Virgil C. Summer Nuclear Station (VCSNS) Units 2 and 3
Combined License Nos. NPF-93 and NPF-94
Docket Nos. 52-027 & 52-028

Subject: VCSNS Units 2 & 3 LAR 16-02: Request for License Amendment and
Exemption: Passive Core Cooling System (PXS) Design Changes to
Address Potential Gas Intrusion

Passive Core Cooling System (PXS) Design Changes to Address Potential Gas Intrusion

UFSAR Figure 3B-14 Bounding Analysis Curve for 8 " CMT Cold Leg Balance Line and Vent, DVI Cold Trap to RV

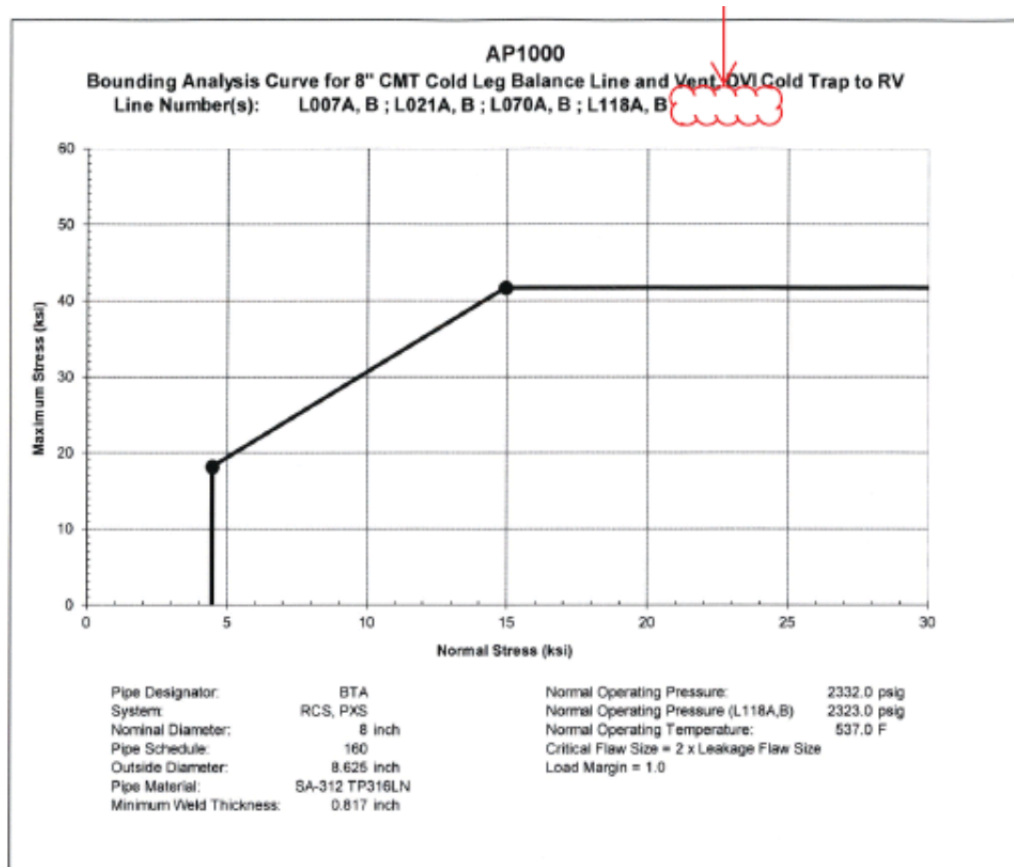
- Move PXS piping lines PXS-L125A and PXS-L125B from Figure 3B-14 to Figure 3B-15; and

Revise Figure as shown below: **L125A, B** deleted from table heading.

UFSAR Figure 3B-15 Bounding Analysis Curve for 8" CMT, DVI IWRST (Various Sections)

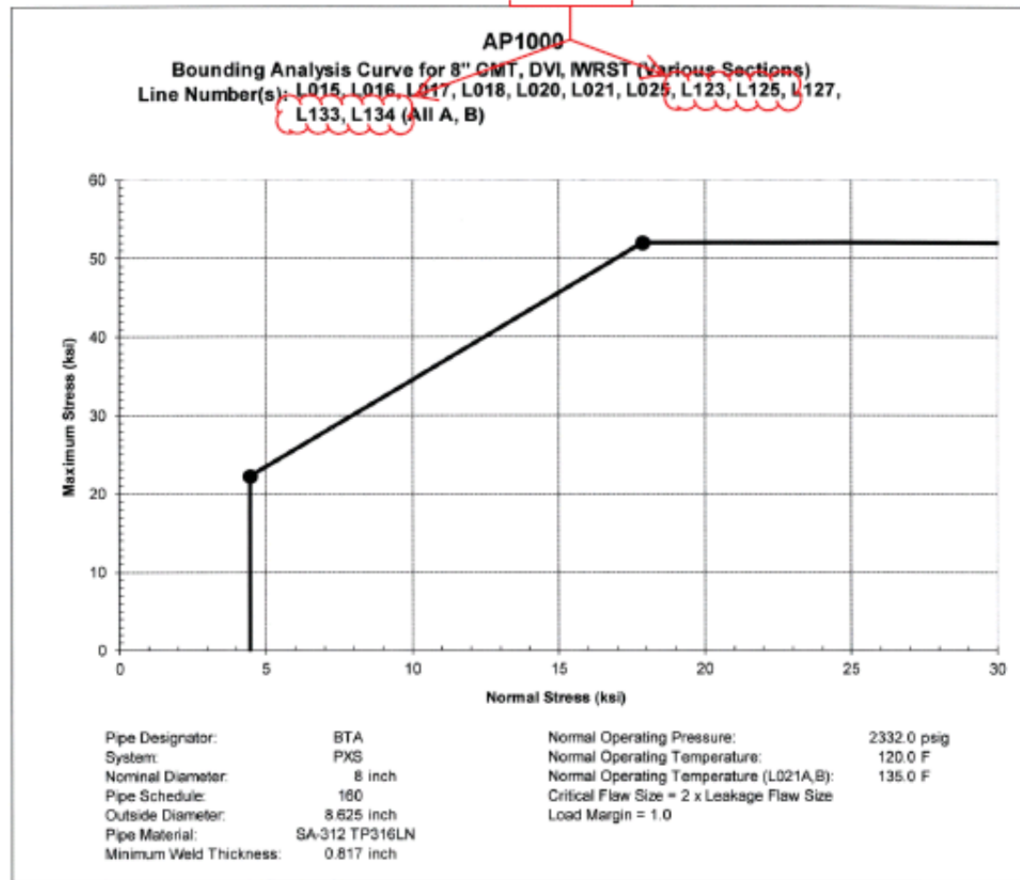
- Add PXS piping lines PXS-L123A, PXS-L123B, PXS-L133A, PXS-L133B, PXS-L134A, and PXS-L134B to Figure 3B-15.
- c) UFSAR Figure 3E-4 Sheet 2 is revised to:

Revise Figure as shown below: [Add L123, L125, L133, L134 to Line Numbers](#)
